SITE EVALUATION

(Ground Absorption Sewage Disposal)

RE: Property located at 10033 E. Independence Blvd.

Reference: Alternate Septic System Proposal 12033 E. Independence Boulevard

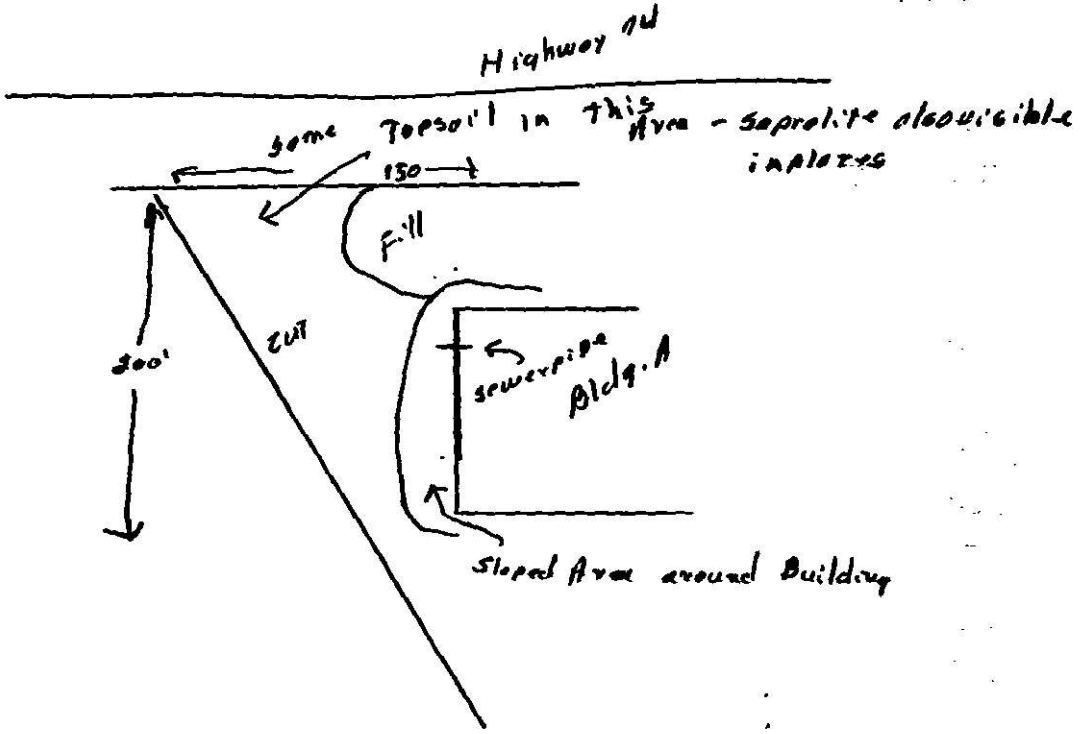
Recommendations/Comments: Sewage pipe stubbed out T Approx 25' From Front of building instead of From rear as shown on plan.
